Access Compliance Report

Public Rights-of-Way

(Curb Ramps)

Intersection ID: 50610	Main Street: GOLDEN_WOOD_LN	Cross Street: DOWNY_BIRCH_RD	Location: NW
ADA ID: AE48A3BDC656	Ramp Type: Perp	Initial Pass/Fail: Fail	Overall Compliance: No
Severity Score: 22.5			
Codes/Mitigation Info/Possible Solution		Field Measurements/Component Compliance

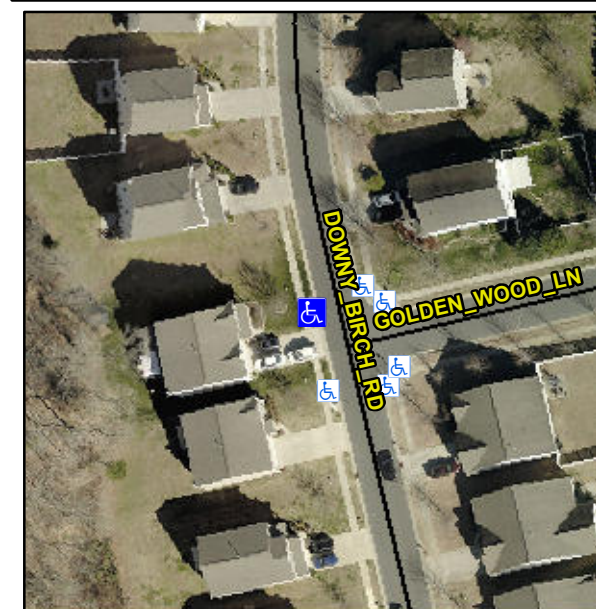
Not Found, R304.5.1, R304.2.2, R304.5.3

Compliance	Description	Data	Compliance	Description	Data
N/A	Ramp Length (in)	47.0	No	Ramp Slope (%)	9.9
No	Ramp Width (in)	47.0	No	Ramp XSlope (%)	3.3
N/A	Flare Type LT	N/A	N/A	Flare Type RT	N/A
N/A	Flare Slope LT (%)	N/A	N/A	Flare Slope RT (%)	N/A
N/A	Flare Traversable LT?	N/A	N/A	Flare Traversable RT?	N/A
N/A	Landing Length (in)	N/A	N/A	DWS Provided?	N/A
N/A	Landing Width (in)	N/A	N/A	DWS Contrast?	N/A
N/A	Landing Slope (%)	N/A	N/A	DWS Length (in)	N/A
N/A	Landing X Slope (%)	N/A	N/A	DWS Full Width?	N/A
N/A	Landing Curb? (Y/N)	N/A	N/A	DWS Offset (in)	N/A
N/A	Shared Landing?	N/A			
N/A	Gutter Ponding?	N/A	N/A	Gutter Slope (%)	N/A
N/A	Gutter Lip Ht (in)	N/A	N/A	Gutter X Slope (%)	N/A
N/A	Painted X Walk1?	No	N/A	Painted X Walk2?	N/A
	X Walk 1 Direction	To E		X Walk 2 Direction	N/A
N/A	X Walk 1 Width (in)	N/A	N/A	X Walk 2 Width (in)	N/A
	X Walk 1 Slope (%)	3.9		X Walk 2 Slope (%)	N/A
	X Walk 1 X Slope (%)	3.8		X Walk 2 X Slope (%)	N/A

Remove & Replace Entire Ramp.
